# UNITED STATES PATENT AND TRADEMARK OFFICE

APPLICATION NO.	FILING DATE	FIRST NAMED INVENTOR	ATTORNEY DOCKET NO.	CONFIRMATION NO.
10/766,671	01/28/2004	Dorian Thurston True	42576/282562	3032
23370	7590	06/27/2007		
JOHN S. PRATT, ESQ KILPATRICK STOCKTON, LLP 1100 PEACHTREE STREET ATLANTA, GA 30309			EXAMINER HAWK, NOAH CHANDLER	
			ART UNIT 3636	PAPER NUMBER
			MAIL DATE 06/27/2007	DELIVERY MODE PAPER

## Office Action Summary

Peta, Figure 2

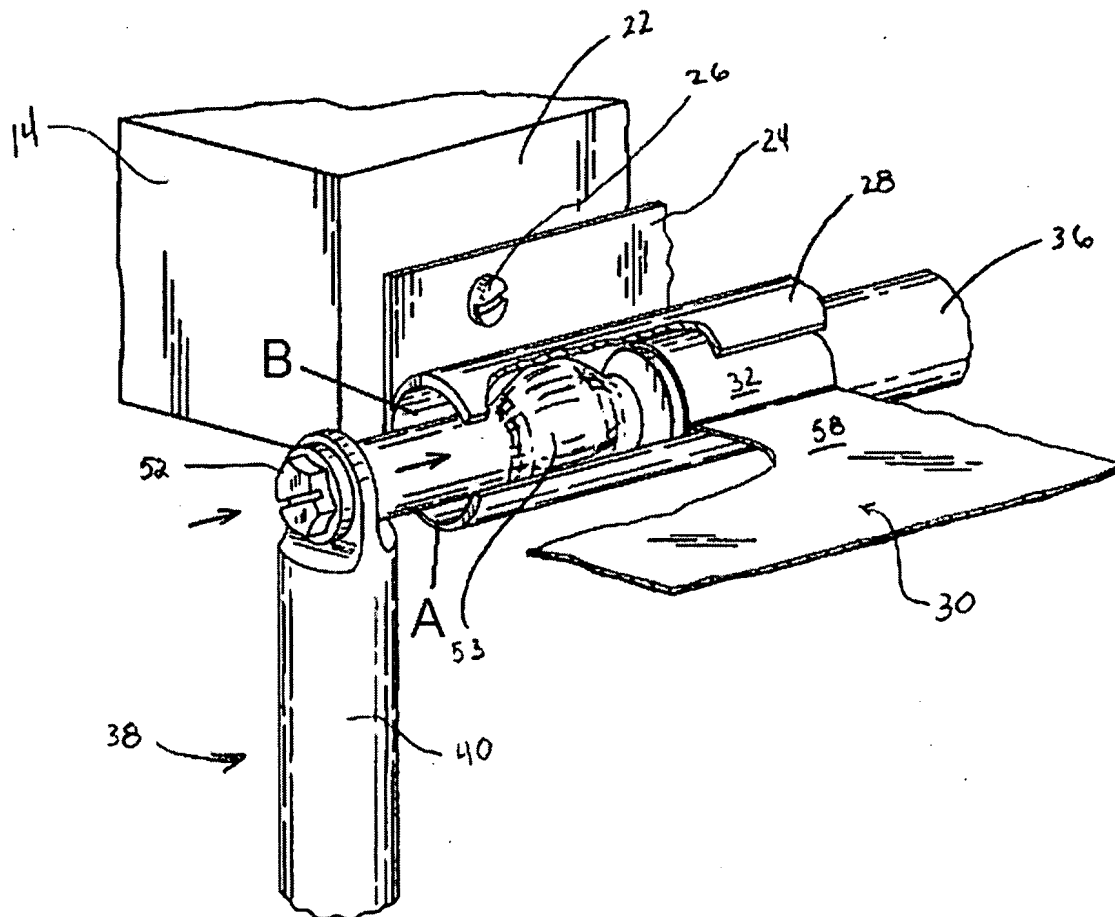
a. Regarding Claim 1, Peta teaches an apparatus for covering the rear of a golf cart, the apparatus comprising a stationary frame member (comprising at least 40, 42 and A), a movable frame member (56), and a cover (58), the stationary frame member mounted on the golf cart by brackets (24).

- b. Regarding Claim 3, Peta teaches that the stationary frame member comprises a U-shaped frame having a horizontal portion (A) and two legs (40, 42).
- c. Regarding Claim 4, Peta teaches that the horizontal portion (A) of the frame member is mounted to the brackets (24).
